# Global Programme to Support Countries with the Shift to Electric Mobility - Addendum

**Review PIF and Make a recommendation**

10544

PFD

Fig. 3. GHG emissions due to the use of electric vehicles in the European Union.

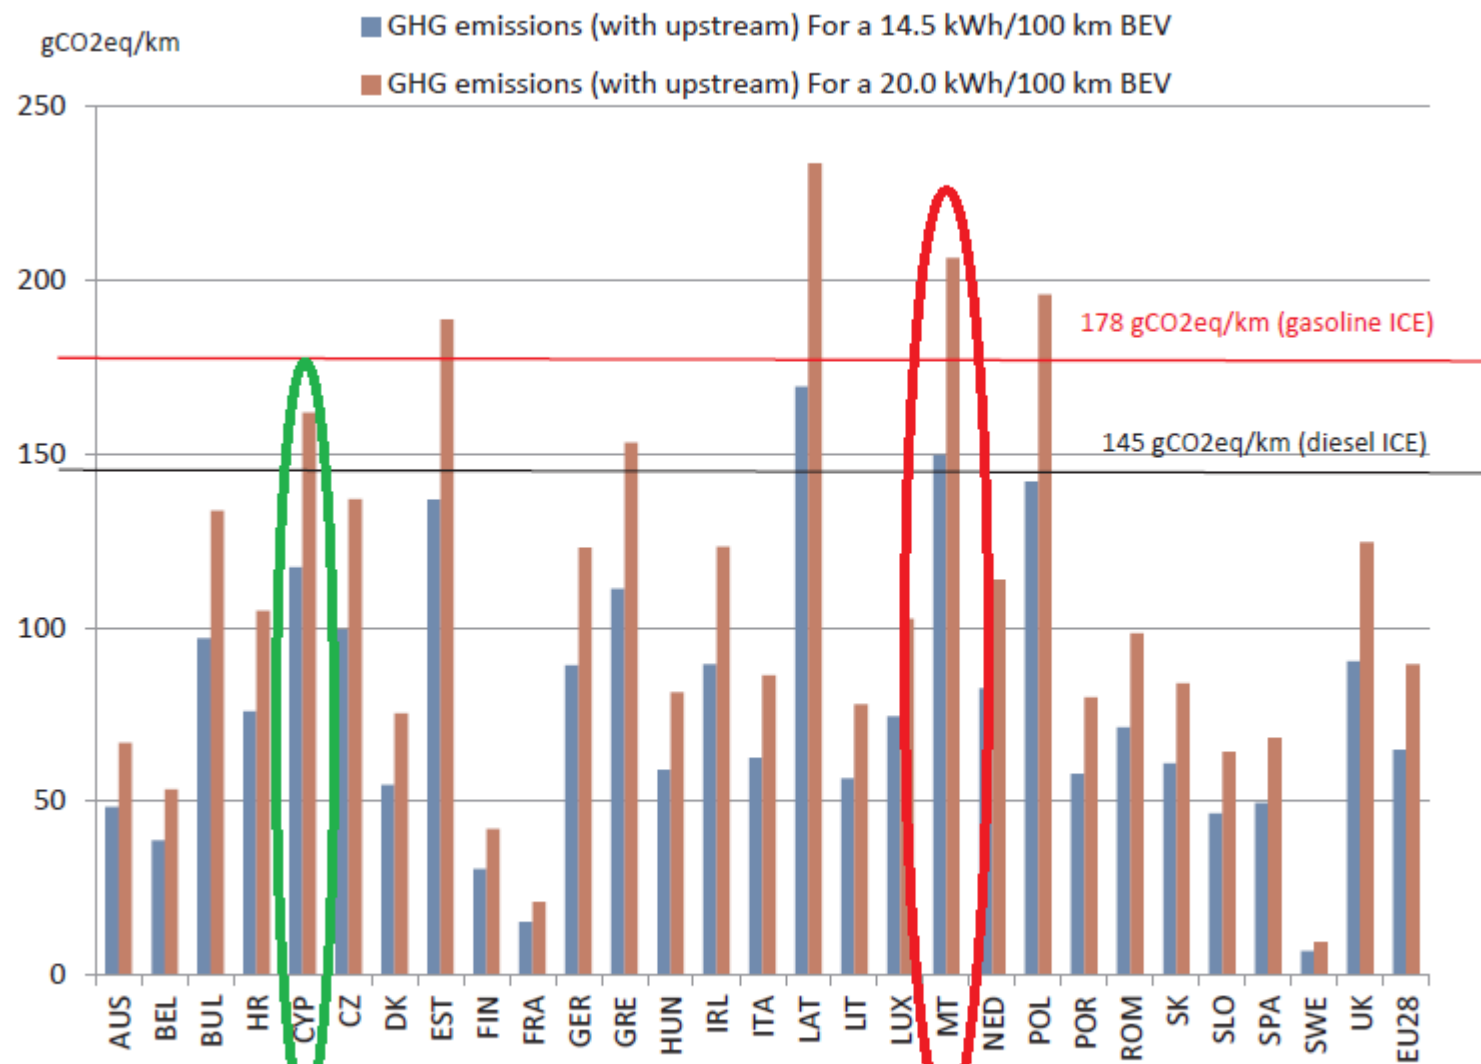
1. PPG grant is above the cap. Either provide justification including break down of costs (GEFSEC will reserve the right to approve or not the exception to the policy).
2. The co-financing from DBSA is missing. According to discussions with DBSA, there should be investment mobilized from DBSA of approximately USD 100million in loans to leverage the GEF resources.
3. With regards to this sentence on page 68:

This intended change in carbon intensity of grid electricity is essential for any electric mobility project in South Africa, since the carbon intensity of today's grid power leads to increased GHG emissions from an electric vehicle compared to a conventional one. In 2015, the transport sector accounted for about 13% of energy related CO<sub>2</sub> emissions, with road transport being responsible for more than 90% of all transport emissions (Figure 2).

It is generally recognized that even in high carbon intensity grid countries, EV are more efficient than ICE in terms of emissions per kilometers. Please include a reference/additional info for this sentence or remove it.

Along the same lines goes the following statement:

Since South Africa has one of the highest grid electricity carbon footprint worldwide, in the near future significant CO<sub>2</sub> emission reductions can only be achieved if the carbon footprint of the electricity used to charge the buses is at least 30% lower than the average grid. This is why the demonstration projects will seek for ways to use lower carbon footprint electricity for example based on agreements with renewable power producers to buy their electricity either for direct use to charge the e-buses, or by off-setting emissions elsewhere in the grid.

Please confirm if there is available literature that has established that ICEs have less emissions than EVs powered with SA grid electricity?

3. The statement has been removed.

Recognizing that additional renewable energy needs to be included in South Africa to reduce emissions with the introduction of electric vehicles, the South African project aims at including a 30% renewable energy share in the electricity mix used for charging the demonstration buses. As shown in Figure 1 of the South Africa concept note, under all scenarios (IRP2 to IRP4) tested in the South African Integrated Resources Plan (2018), the share of coal in the power mix will be reduced by approximately 50% (from currently 81% of the total electricity production to around 40%) by 2040. The reduction in coal-based power production will be replaced almost entirely by renewable energies (wind, solar PV, CSP and hydro). This gradual increase in the share of renewable power generation in the South Africa's energy mix will therefore contribute to the reduced CO<sub>2</sub> emissions stemming from the electric vehicles – and this was also considered when estimating the GHG emission reductions for the South Africa e-mobility proposal. Please also refer to our responses to comment No. 3 in the section 6. of the review sheet dedicated to “contributions to global environmental benefits” further down.

Please also see analysis from EU JRC on EV emission mitigation within various EU grids (Electricity carbon intensity in European Member States: Impacts on GHG emissions of electric vehicles, Alberto Moro, Laura Lonza European Commission, Joint Research Centre (JRC), Via Enrico Fermi 2749, 21027 Ispra (VA), Italy, <https://www.sciencedirect.com/science/article/pii/S1361920916307933> ). Data from Cyprus and Malta, which respectively have similar grid emission factors to Indonesia and South Africa, respectively, show the impact of the grid emission difference on GHG emission savings from EVs.
